# Access Compliance Report

## Public Rights-of-Way

| Intersection ID: 50517                  | Main Street: STEWART_TERRACE_WY | Cross Street: MICHAEL_CROSSING_DR       | Location: S            |
| ADA ID: E4882283FA6C                    | Ramp Type: Perp                 | Initial Pass/Fail: Fail                 | Overall Compliance: No |

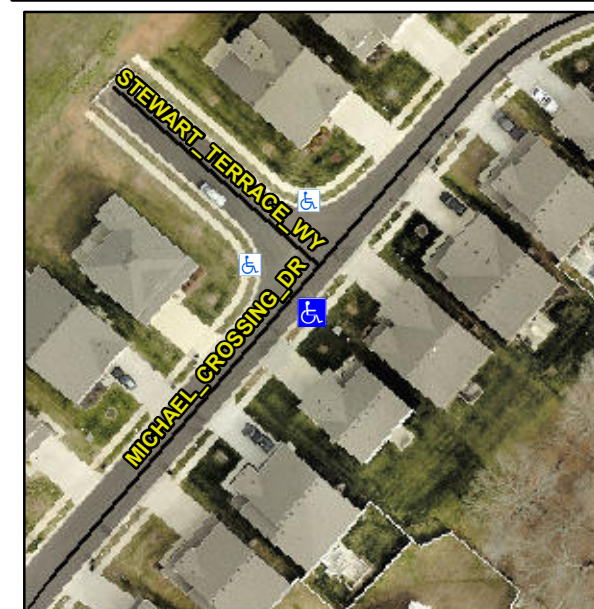
**Not Found, R304.2.2**

| Compliance | Description           | Data  | Compliance | Description                 | Data |
|------------|-----------------------|-------|------------|-----------------------------|------|
| N/A        | Ramp Length (in)      | 46.0  | No         | Ramp Slope (%)              | 10.6 |

**Remove & Replace Entire Ramp.**
